**SUBDIVISION COMMITTEE  
METROPOLITAN AREA PLANNING COMMISSION**

STAFF REPORT  
(Preliminary Plat)

CASE NUMBER: S/D 92-2 - CORDEL FARMS ADDITION

VICINITY MAP:

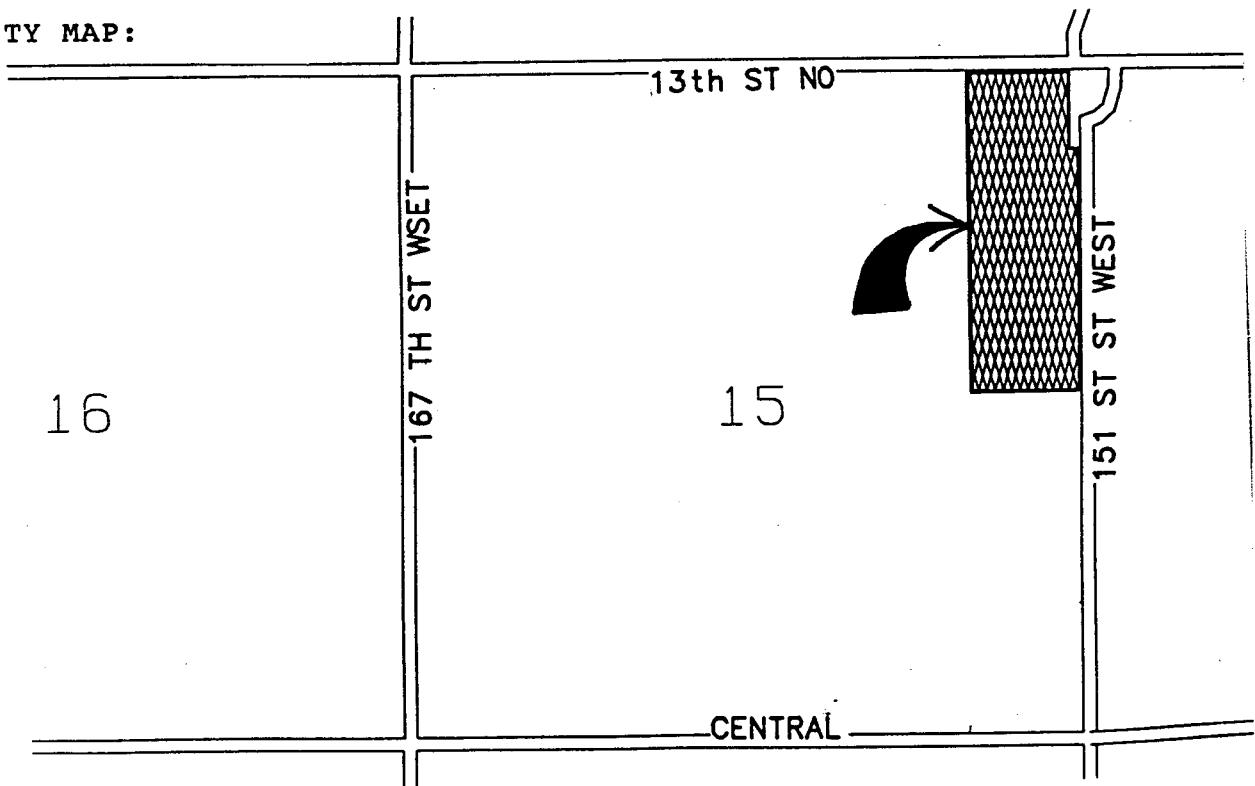
- A. Since neither municipal water nor sanitary sewer is available to serve this property, the applicant shall contact the Environmental Health Division of the Health Department to find out what tests may be necessary and what standards are to be met for approval of on-site sewerage facilities and water wells. A memorandum shall be obtained specifying approval.

- D. Since both 13th St. N. and 151st St. W. are mile line roads, access control needs to be platted from adjacent lots. Based upon the usable frontages of the lots, one access opening from each lot which should be indicated to the adjacent street. The plattor's text shall also note the dedication of this access control.

- E. The applicant shall provide proof, by letter or by copy of the pipeline easement agreements, that the pipeline easements as shown are sufficient and that utilities may be located adjacent to and within the easements. Any relocation, lowering or encasement of the pipeline, required by this development, will not be at the expense of the County.

For the pipeline running along the east line of this plat, the indicated building setback is apparently from that pipeline. However, in order to assure that a setback would still be recognized in the event the pipeline was to relocate or alter its setback requirements, the setback along the east line of the plat should be labeled "Platted and Pipeline Building Setback."

- F. On the final plat the names of the pipeline companies holding the easements shall be indicated along with the recording information for the easements.
- G. Since this plat involves the platting of floodways, the plattor's text on the final plat shall reference the standard floodways language. Further, as requested by County Engineering, the applicant shall submit a covenant concerning the County's

- H. If this plat requires the platting of minimum building pad elevations, such elevations shall be noted on the face of the plat and also shall be referenced in the plat's text. It shall be indicated if these elevations are for the lowest level or opening. Also, both on site and off site benchmarks shall be indicated.

- I. Approval of this plat will require a waiver of the lot depth to width ratio of the Subdivision Regulations. The Subdivision Regulations state that, "the maximum depth of all residential lots shall not exceed 2-1/2 time the width thereof."

- O. The representative from County Engineering should be prepared to comment on the status of the applicant's drainage concept. Also, Engineering needs to indicate if the floodway boundaries appears adequate and what minimum building pad elevations are required.
